# Technical Service Bulletin

<b>Subject:</b>  <b>WRONG VEHICLE LOCATION IN GPS WITH DTCS B119F:01, B119F:13 AND/OR B119F:2B STORED</b>	<b>Bulletin No.:</b> 09-021/20
	<b>Last Issued:</b> 06/25/2020

2019-2020 Mazda3  
2020 CX-30

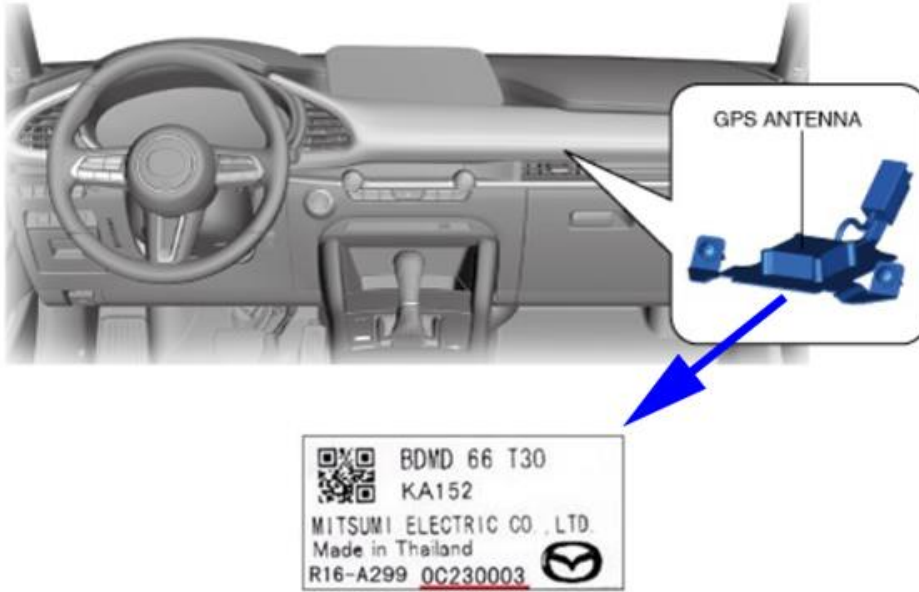
1. Verify customer concern.
2. Confirm if the telephone antenna No.1's lot number is before 0C230003. The lot number is in YMDDnnnn format.

- If the lot number is 0C230003 or later, the part is already modified.
- If the lot number is before 0C230003, replace the GPS antenna with a modified one by referring to the instructions on MGSS.
  - Mazda3: (GLOBAL POSITIONING SYSTEM (GPS) ANTENNA REMOVAL/INSTALLATION)
  - CX-30: (GLOBAL POSITIONING SYSTEM (GPS) ANTENNA REMOVAL/INSTALLATION)
